Economic Commission for Europe**Inland Transport Committee****World Forum for Harmonization of Vehicle Regulations****Working Party on General Safety Provisions****124th session**

Awareness of the Proximity of Vulnerable Road Users:**UN Regulation No. XXX (Vulnerable Road Users Direct Vision)****Proposal for an Amendment to the New UN Regulation No. [XXX] (Vulnerable Road Users Direct Vision)****Submitted by the expert from the Informal Working Group on Awareness of Vulnerable Road Users Proximity ***

Figure 1

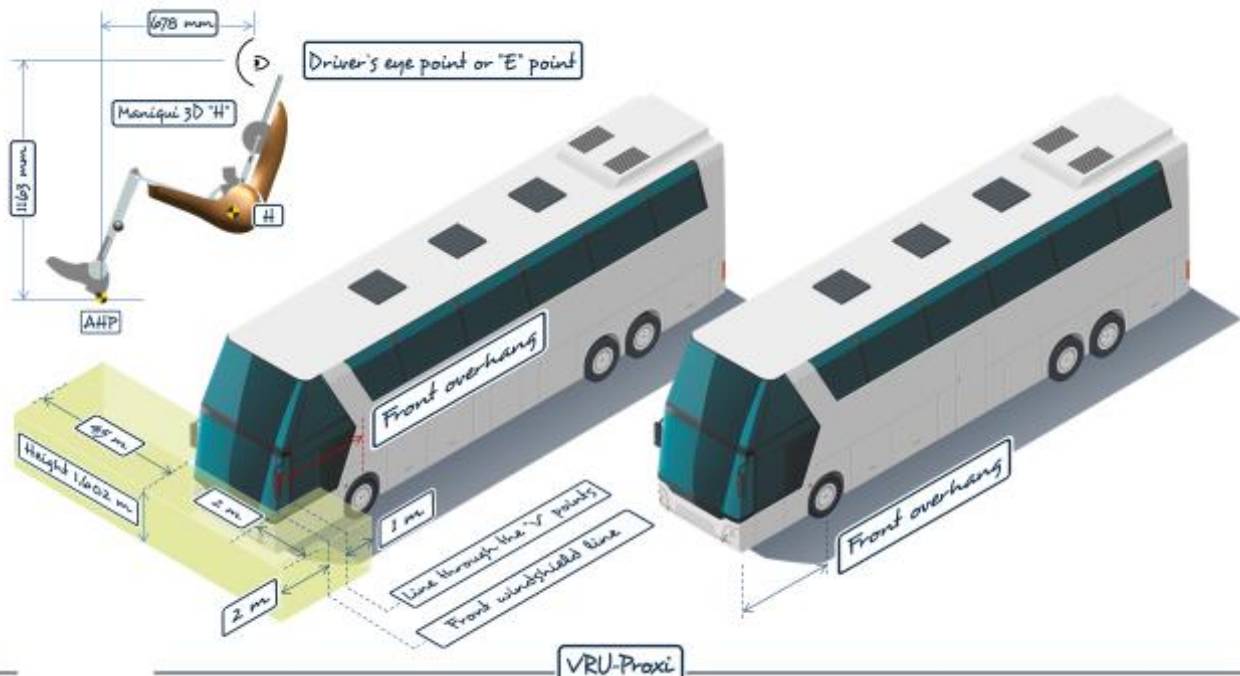
The testing procedure has been seen to be independent of the distance between the front axle and the foremost point of the vehicle. The reference point is the Accelerator Heel Point. Further explanations are given in figures 1 to 3 below.
